# Meeting Notes

**Project:** I-70 Floyd Hill to Veterans Memorial Tunnels NEPA and 30% Design  
**Meeting:** 21912 Floyd Hill SWEEP #2  
**Date:** October 25, 2018  
**Location:** CDOT Golden Region 1, Lookout Mountain

**SWEEP Meeting #2**

# PROPOSED SEDIMENT CONTROL LAYOUT

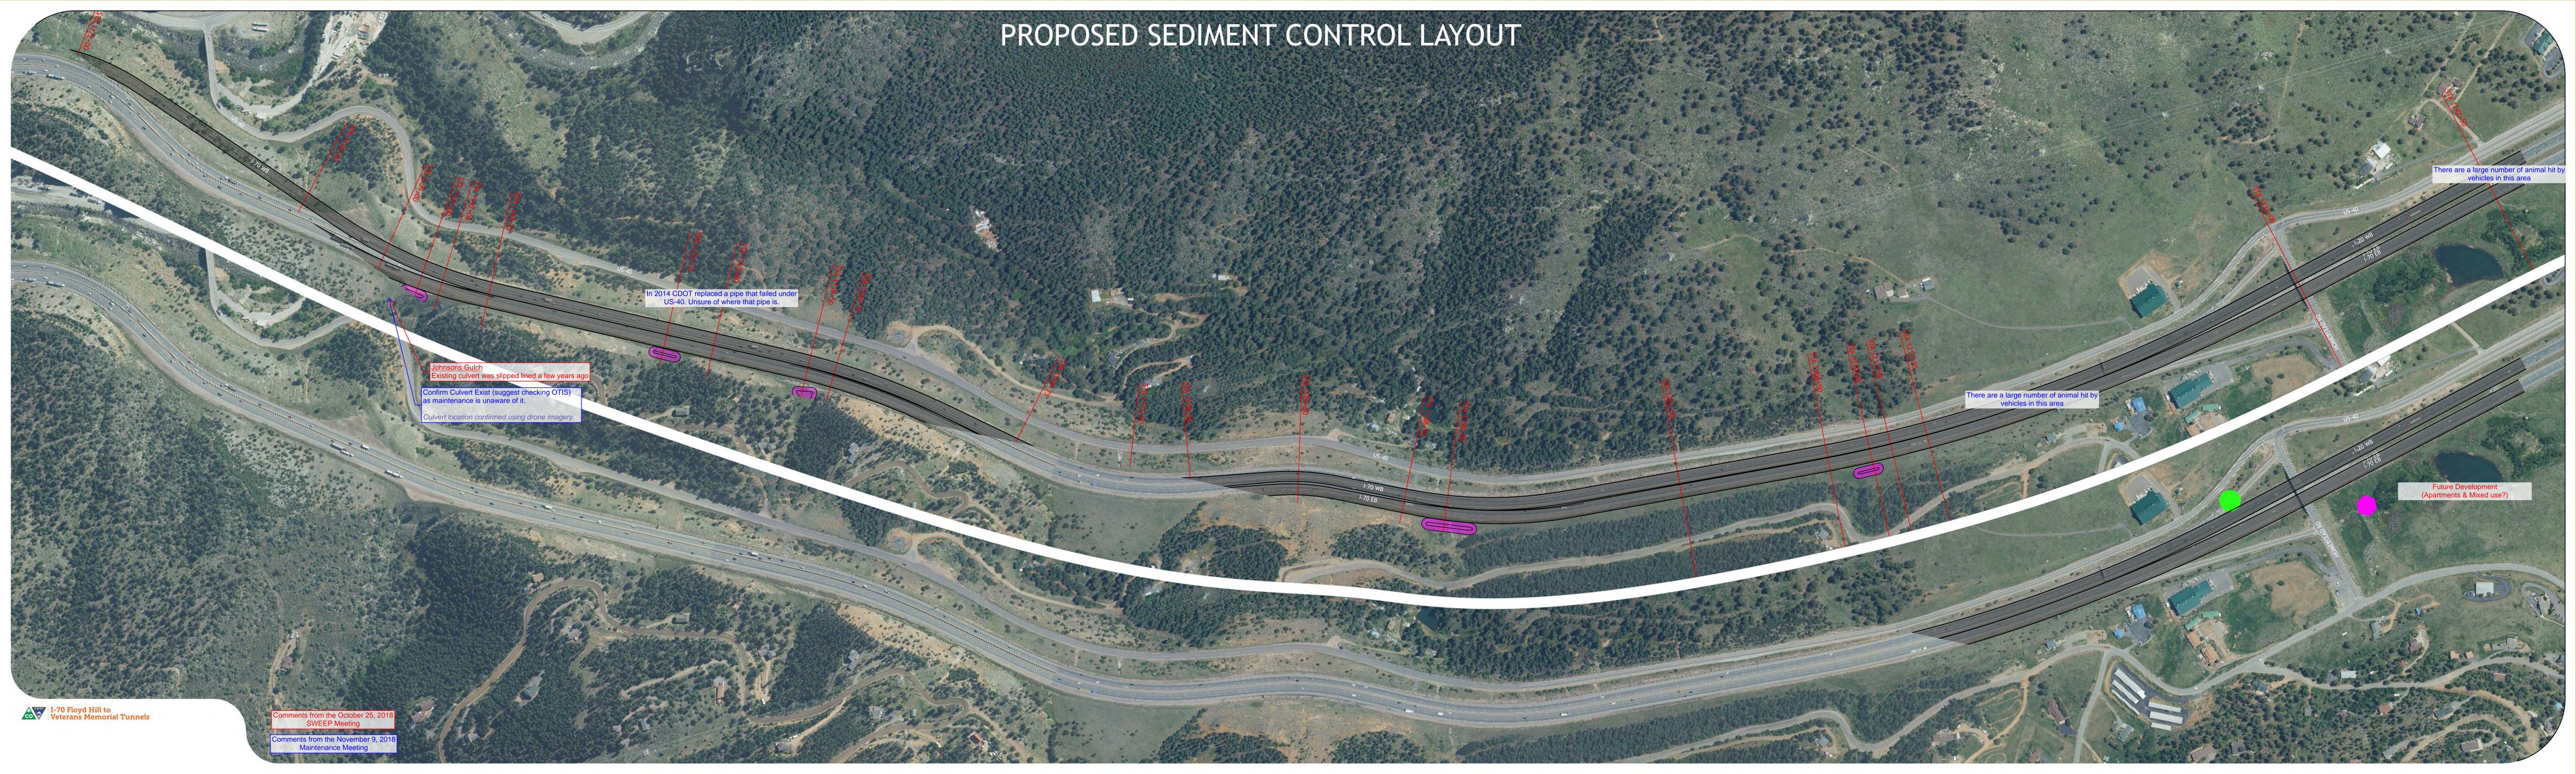
Johnsons Gulch  
Existing culvert was slipped lined a few years ago  
Confirm Culvert Exist (suggest checking OTIS)  
as maintenance is unaware of it.  
Culvert location confirmed using drone imagery.

In 2014 CDOT replaced a pipe that failed under  
US-40. Unsure of where that pipe is.

There are a large number of animal hit by  
vehicles in this area

There are a large number of animal hit by  
vehicles in this area

Future Development  
(Apartments & Mixed use?)
